UNITED STATES PATENT AND TRADEMARK OFFICE

APPLICATION NO.	FILING DATE	FIRST NAMED INVENTOR	ATTORNEY DOCKET NO.	CONFIRMATION NO.
10/694,134	10/27/2003	Wilbur Keith Moffatt	913/40148A	3238

Office Action Summary

DETAILED ACTION

FIG. 1

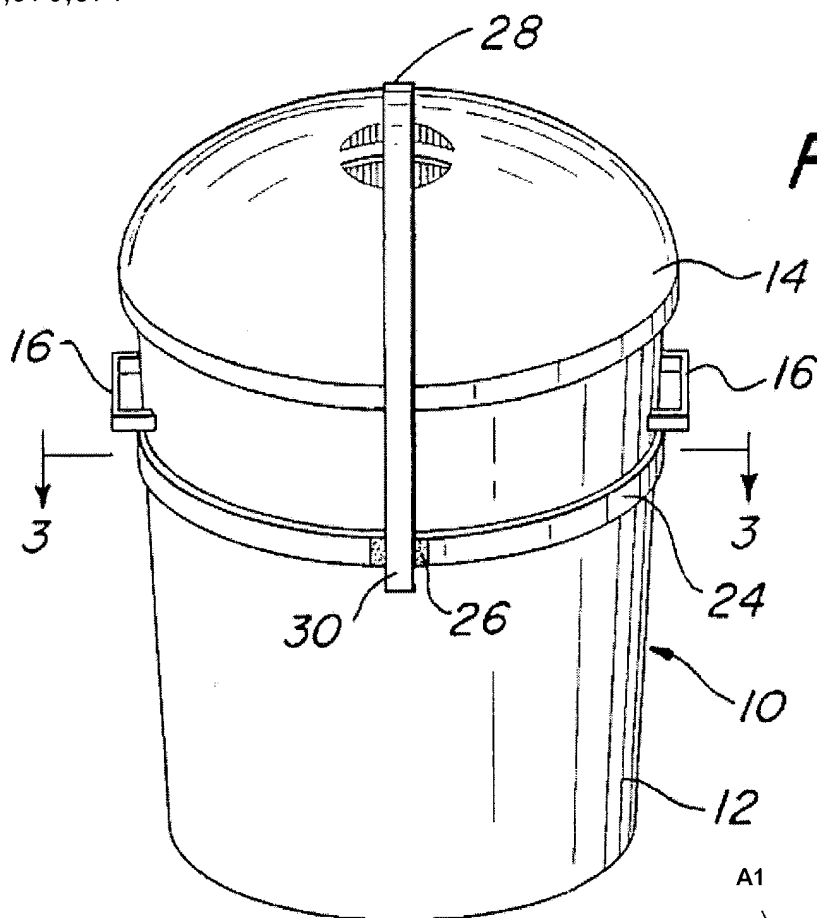
Regarding claim 1, Wise et al. disclose, in Figures 1 and 2, a retainer assembly comprising a first section **A1**, a second section **A4**, a third section **24**, and an outer pole **12**. The first section **A1** has a first portion **A2** and a second portion **30**. The second section **A4** has a first portion **A5** and a second portion **36**. The third section **24** is positioned around the outer pole **12** which is fastened to the second portion **30** of the first section **A1** and the second portion **36** of the second section **A4**.

However, Wise et al., fail to disclose the first portion **A2** of the first section **A1** and the first portion **A5** of the second section **A4** able of fastening to one another across an open end of the outer pole to retain at least one inner pole within the outer pole. Coulter et al. teach a first portion **3A** of a first section **1A** and a first portion **3B** of the second section **1B** able of fastening to one another across an open end of an outer pole **10** to unfasten the retainer assembly from an open end of the outer pole instead from a side as taught by Wise et al. Therefore, as taught by Coulter et al., it would have been obvious to one of ordinary skill in the art at the time the invention was made to modify Wise et al. to be able to fasten the first portion of the first section with that of the first portion of the second section across an open end of the outer pole versus from the side of the outer pole.
